# COMBINED LINWOOD/EASTERN INTERCHANGE & US 50/RED BANK INTERCHANGE FOCUS AREA ADVISORY COMMITTEE MEETING NOTES

EASTERN CORRIDOR SEGMENTS II AND III (PID 86462)

## MEETING #3 NOTES

Sept. 7, 2018

**Figure I-20B**  
**ROUNDAABOUT AT WOOSTER PIKE  
 AND RED BANK ROAD INTERSECTION**

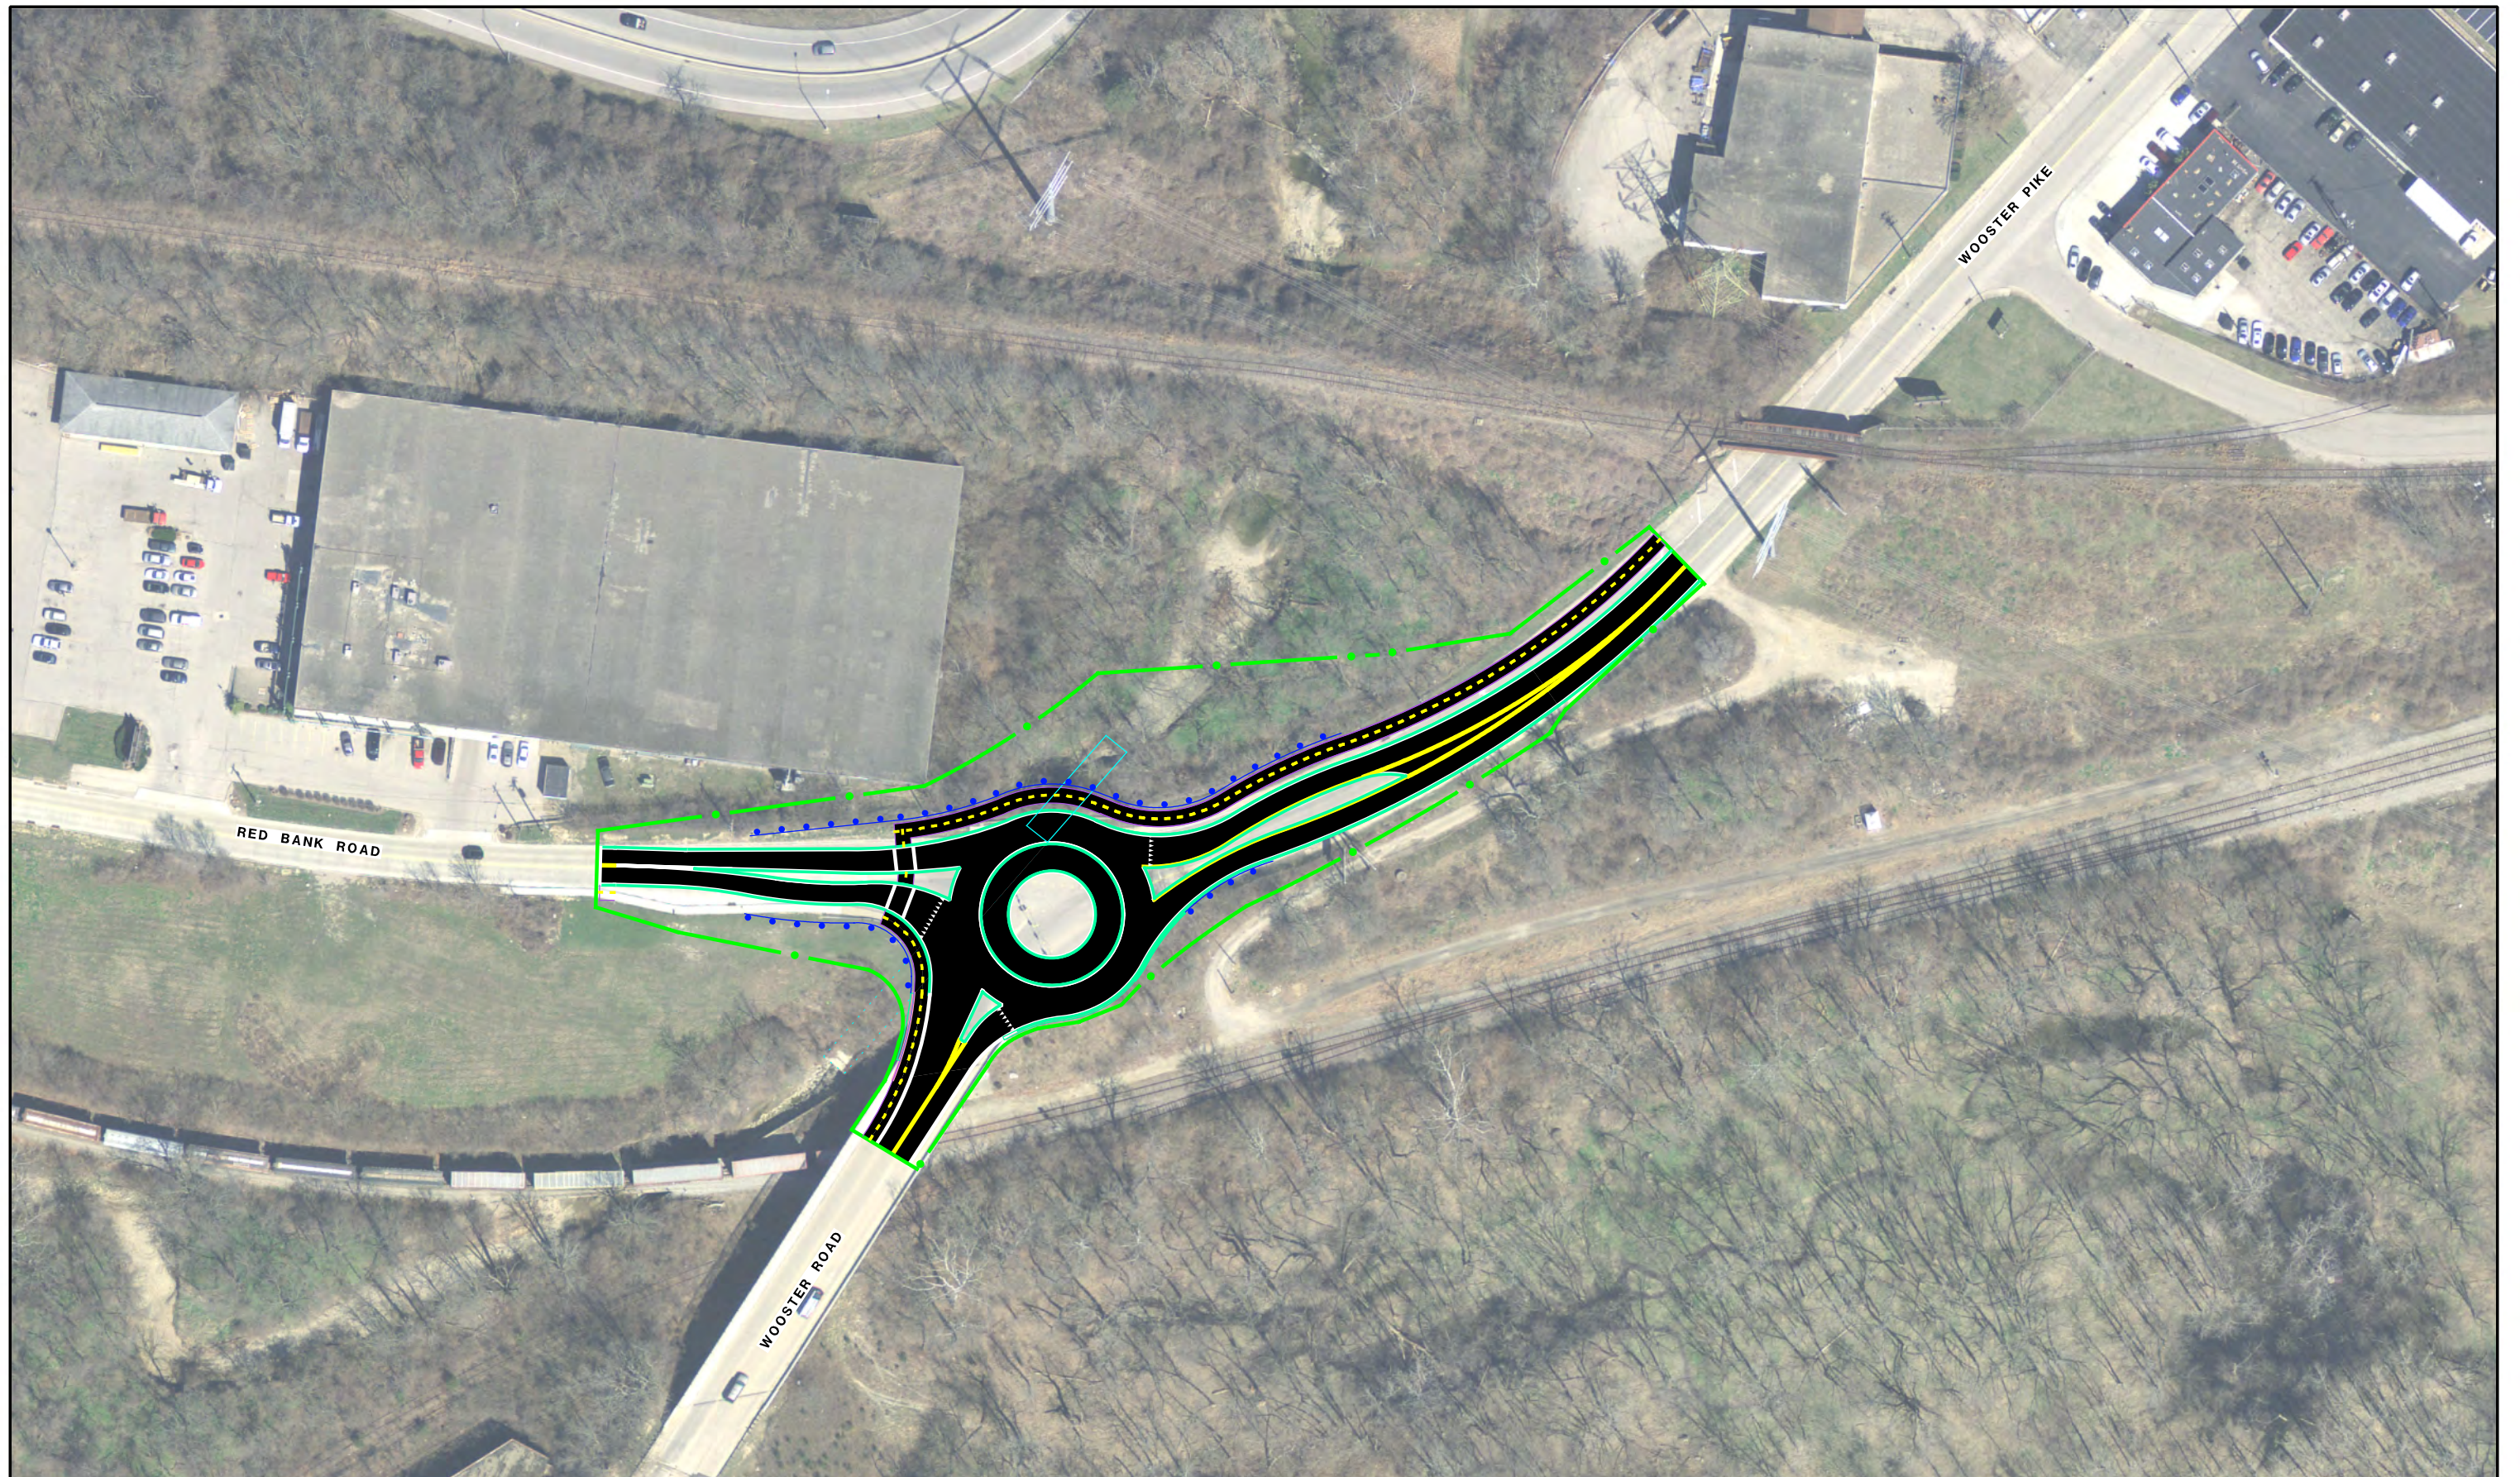
- A roundabout would be designed to comfortably accommodate trucks.
- Would only need to use two lanes instead of three on the bridge, and it would be possible to get a bike lane across the bridge over the railroad without widening the existing bridge.
- Initial analysis indicates:
  - No change in delays during morning peak-hours.
  - A 20 percent increase in delays during evening peak-hours.
- Team will consider how best to incorporate multi-use path connections into this concept.

- Advance for public consideration.

### Figure BIKE-1

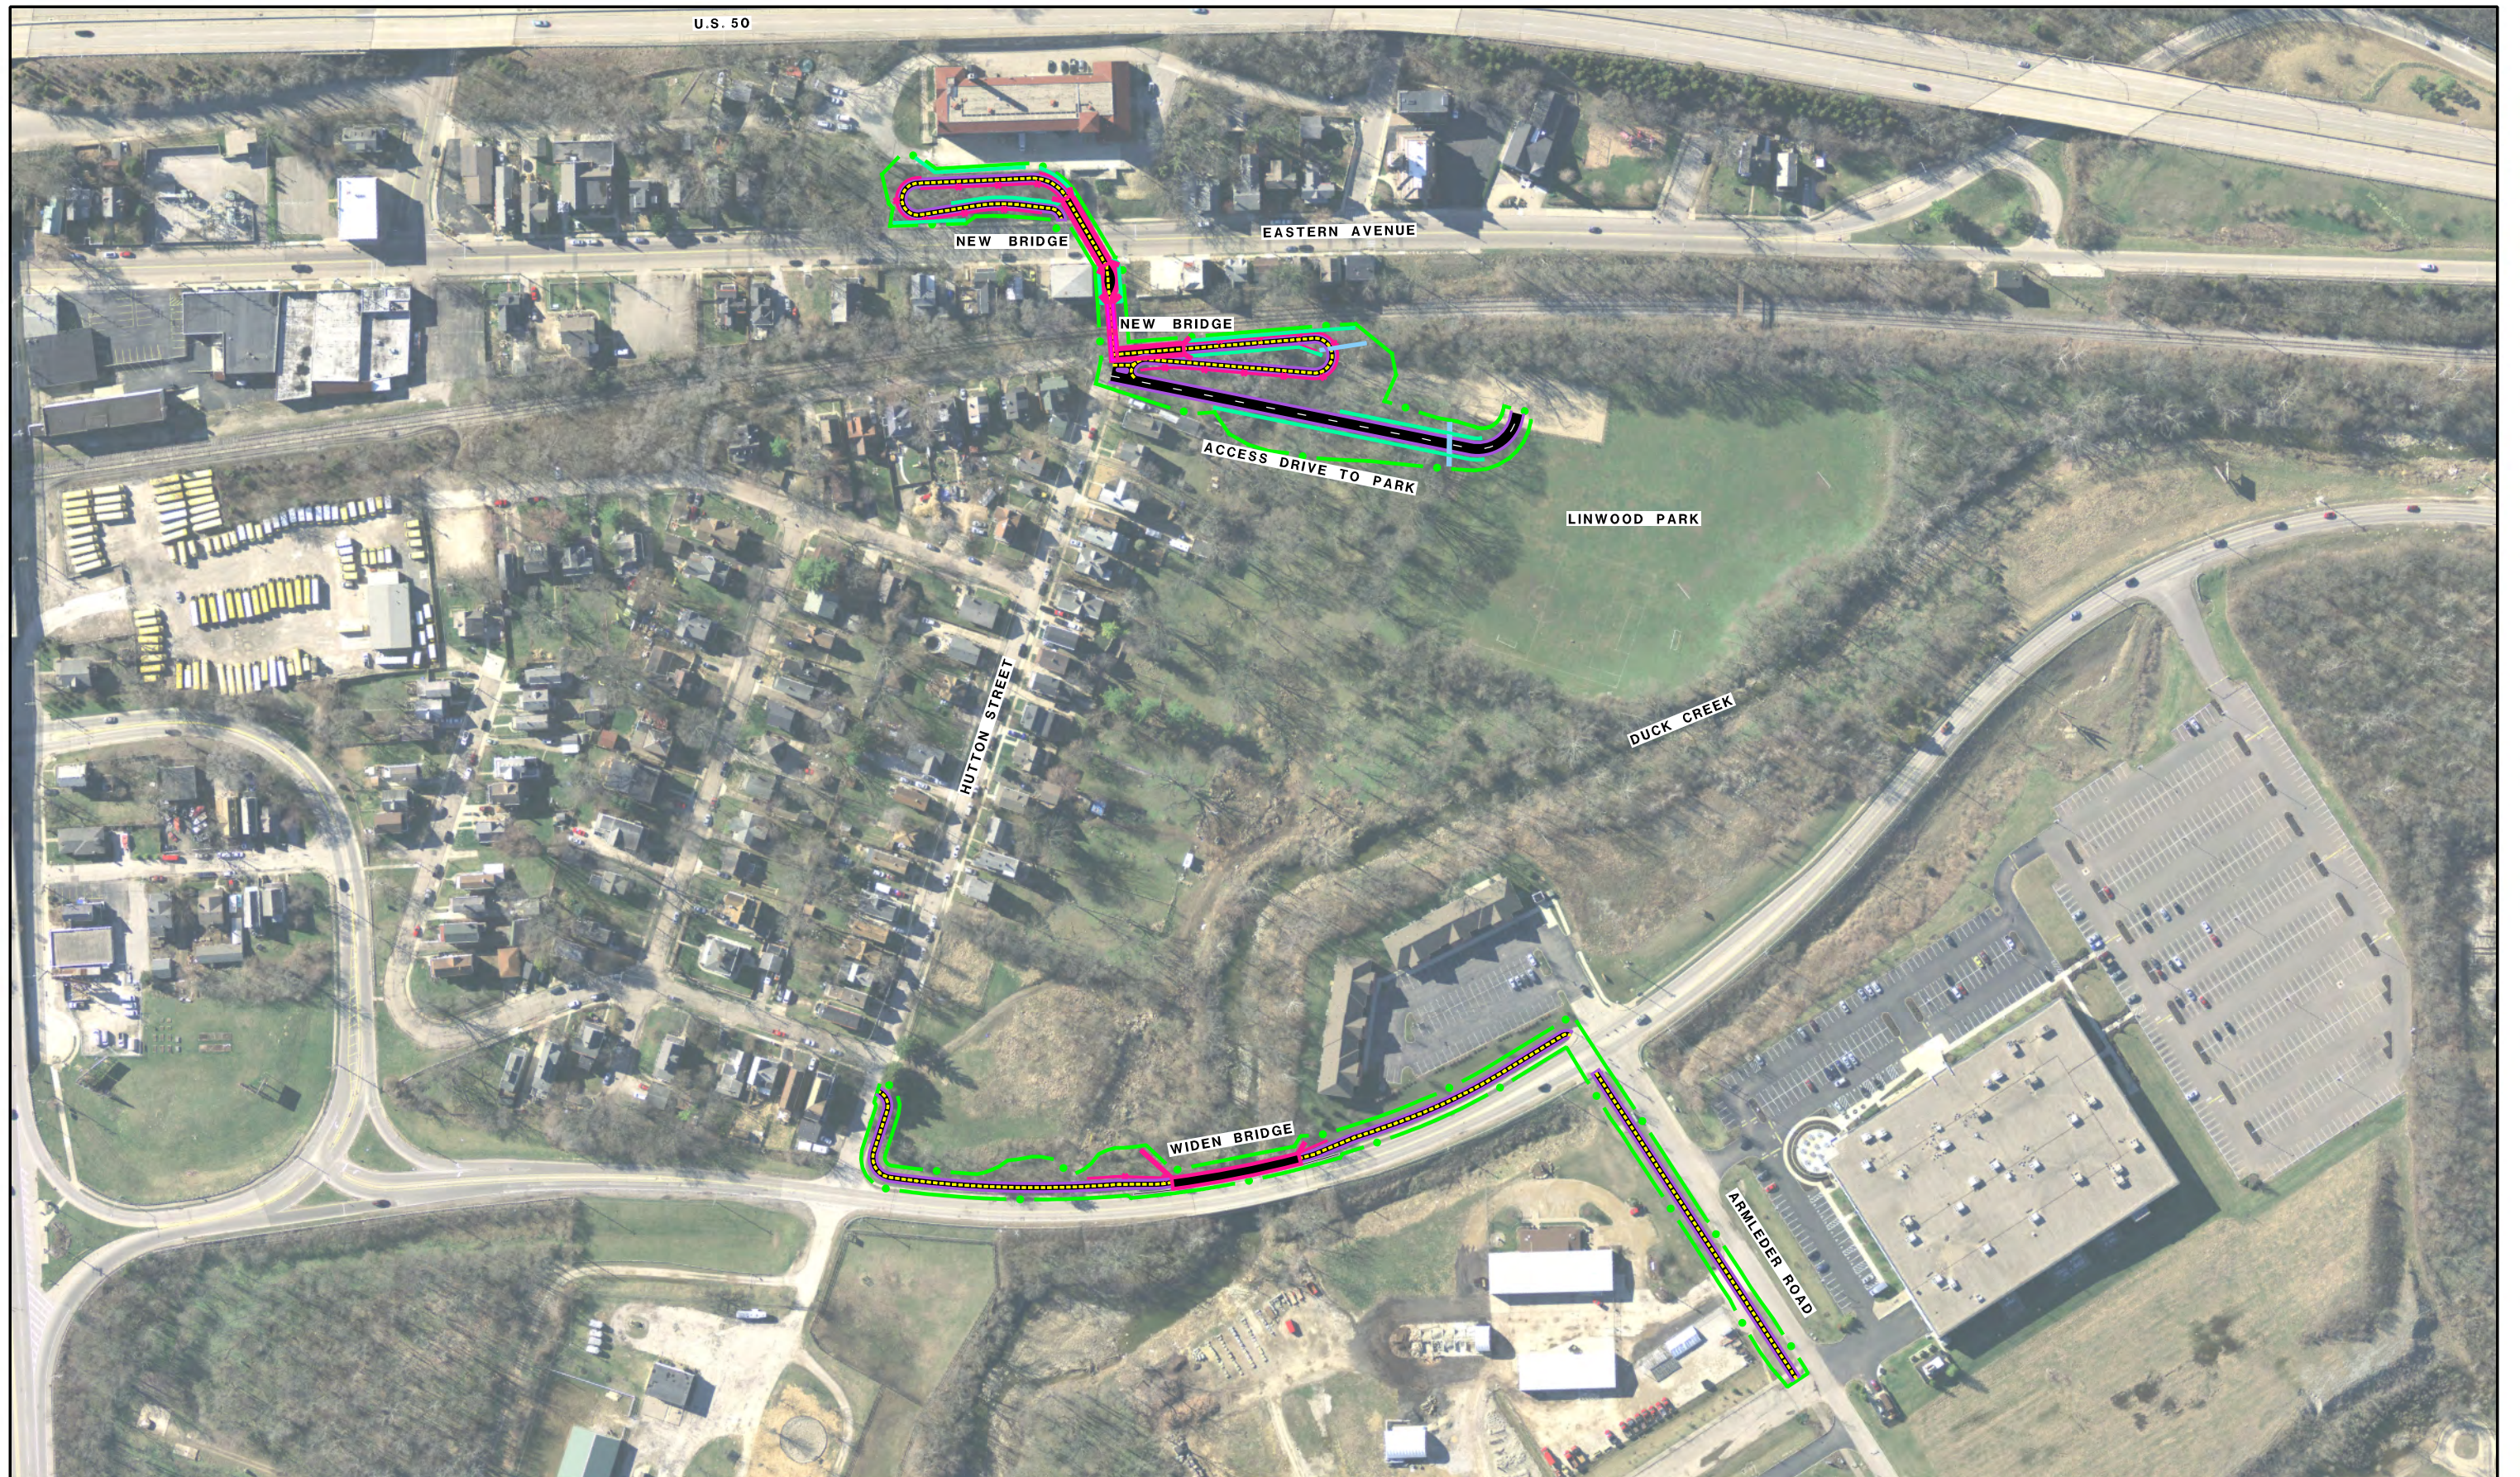
- The existing pedestrian bridge over the railroad is not bike friendly.
- The Committee expressed interest in placing the bike path along existing streets instead of establishing a new connection through the park and across the creek. The City’s Linwood Plan already discusses adding a bike path along Wooster Road from Beechmont Circle to Armleder.

- It uses the location of the existing pedestrian concrete bridge over the railroad tracks (across from the old school) to add a bike path from Eastern Avenue across the railroad tracks onto Hutton Avenue.
- The new bike path would loop up through the front yard of the old school and down into Linwood Park (a new access drive to the park would be needed).
- From there, the path would continue down Hutton to Wooster Pike and then to Armleder Road.
- The existing sidewalk along Wooster Pike would be widened to a shared-use path.
- The BIKE-2a concept has a connection from Eastern to Armleder that accomplishes a similar result but at a more reasonable cost.

- No further study due to high costs and impacts. Crossing from BIKE-2a looks more promising. This will become BIKE-1a.
